DEPARTMENT OF NATURAL RESOURCES  
DIVISION OF OIL, GAS AND MINING

Re: State Decision Document and Technical Analysis, New Lease,  
Genwal Coal Company, Inc., Crandall Canyon Mine, ACT/015/032,  
Folder #2, Emery County, Utah

UTAH DIVISION OF OIL, GAS & MINING  
STATE DECISION DOCUMENT AND  
TECHNICAL ANALYSIS

Genwal Coal Company, Inc.  
Crandall Canyon Mine  
New Lease  
ACT/015/032  
Emery County, Utah

**Figure 5**

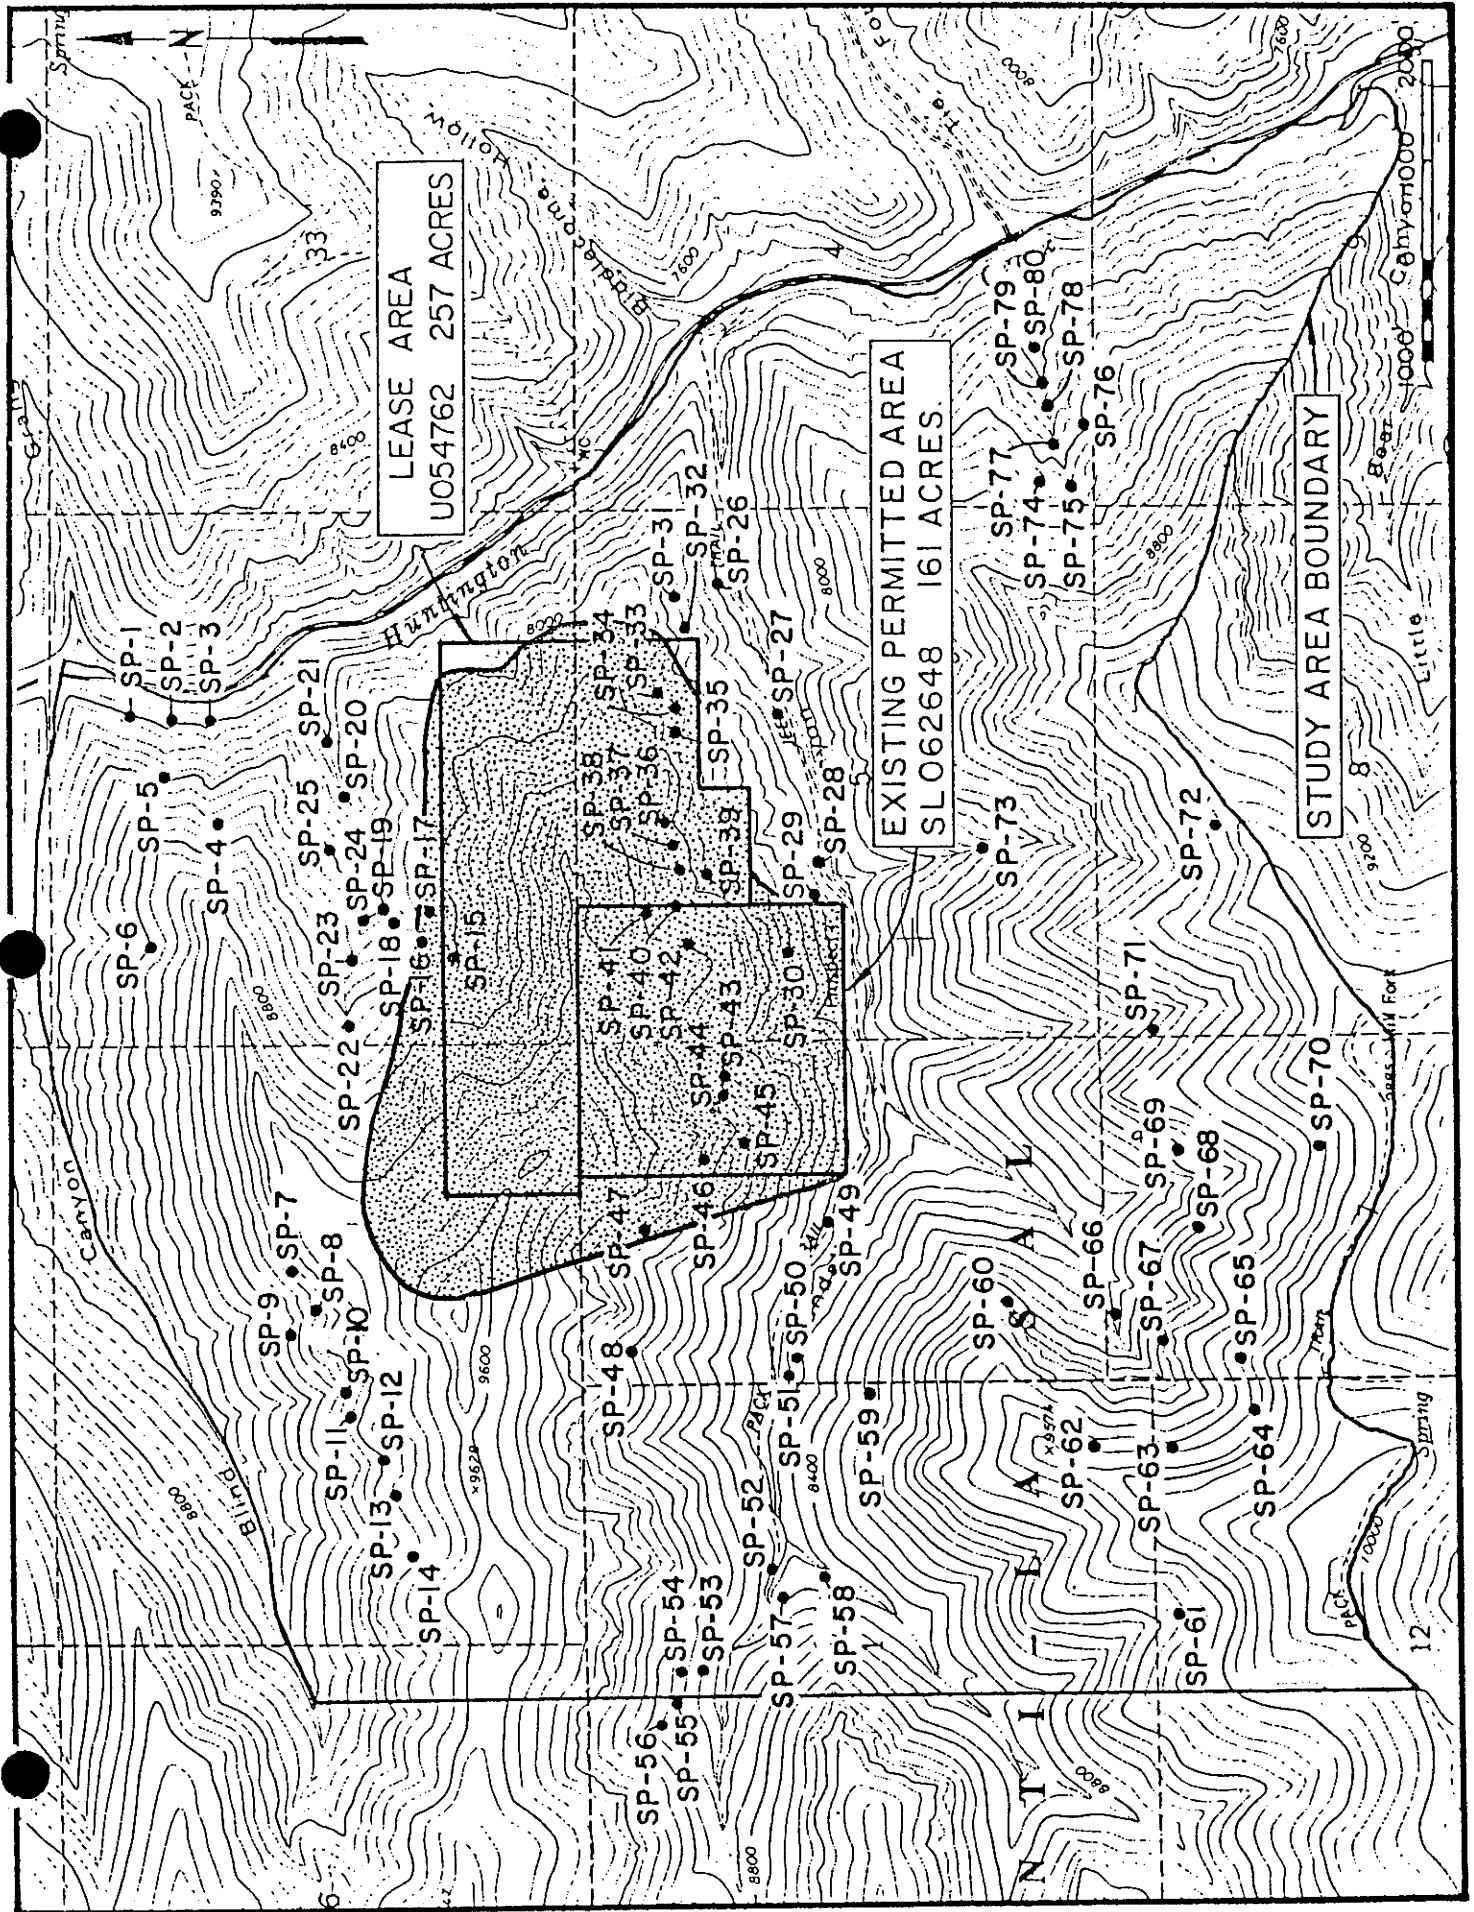
Subsidence impacts are largely related to extension and expansion of the existing fracture system and upward propagation of new fractures. Potential area of impacts is shown on Figure 5. Inasmuch as vertical and lateral migration of water appears to be largely controlled by fracture conduits, readjustment or realignment in the conduit system may potentially produce changes in the configuration of ground-water flow. Potential changes include increased flow rates along fractures that have "opened" and diverting flow along new fractures or permeable lithologies. Subsurface flow diversions may cause the depletion of water in certain localized aquifers, whereas increased flow rates along fractures would reduce ground-water residence time and potentially improve water quality.
